THE WARNER AIRCRAFT CORPORATION

SERVICE LETTER NO. A-9

Subject: Replacement of Link Rod Bolts.

FIG. 1 FULL SIZE

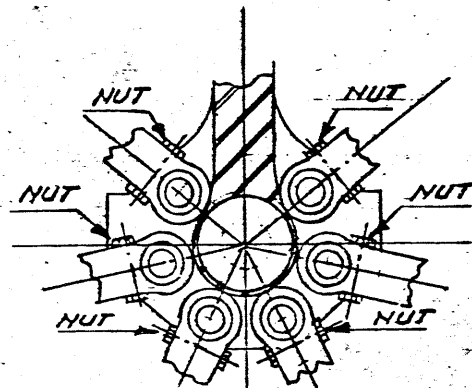
We have found it advisable to bring out a new link rod bolt--part No. 7072-B. This bolt is considerably stronger than the old bolts and, in addition, the section locking the wrist pin is surface-hardened so as to eliminate wear. It can be distinguished from the older bolts by the length of the undercuts and of the center section as shown on Figure 1 below. The following engines were equipped at the factory with 7072-B bolts and are not affected by this Service Letter: 145 H.P. Super Scarab engine No. SS-733 and up and 165 H.P. Super Scarab engine No. SS-2024 and up.

Most of the engines are equipped with bolt No. 7072 which does not have the second undercut next to the thread. We wish to advise all owners of these Super Scarab engines that at the first opportunity this part should be changed in accordance with instructions given below. These bolts can readily be changed during a top overhaul, while the cylinders are removed, without disassembling the crankcase.

Some recent engines are equipped with bolt No. 7072-A which can be recognized by the $\frac{1}{4}$ " long undercuts next to the head and next to the thread and by the center section being approximately $\frac{29}{64}$ " long. These bolts do not have the center section hardened and are installed in 145 H.P. Super Scarab engines No. SS-708E and SS-717E to SS-732E. They are not installed in any Model 165 engine. These bolts need only be changed if they show wear on the center section.

FIG. 2 QUARTER SIZE

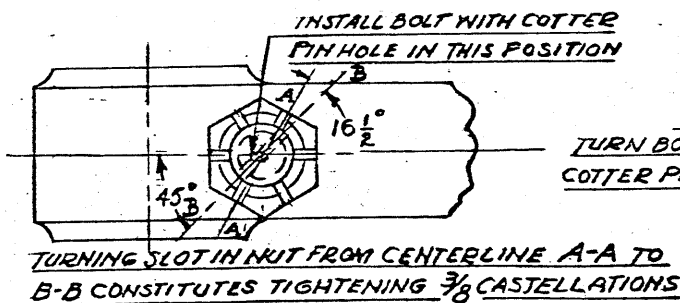
1. Continued.
face in contact with the link rod.
2. Install all link rod bolts with the threaded end towards cylinder No. 1 as shown on Figure 2 below and with the cotter pin hole in the position shown in Figure 3, especially when installing during a top overhaul, in order to facilitate the insertion of the cotter pin.

FIG. 3 FULL SIZE

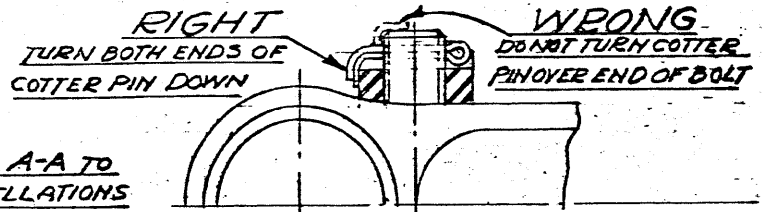
6. Tighten the nut from approximately $\frac{3}{8}$ of a castellation (approximately $16\frac{1}{2}$ degrees) to a maximum of $1\frac{1}{4}$ castellations (approximately 75 degrees) as shown in Figure 3 below. (This method of tightening has been found more satisfactory than using a torque wrench which is influenced by the amount of lubrication and the fit between the nut and bolt).
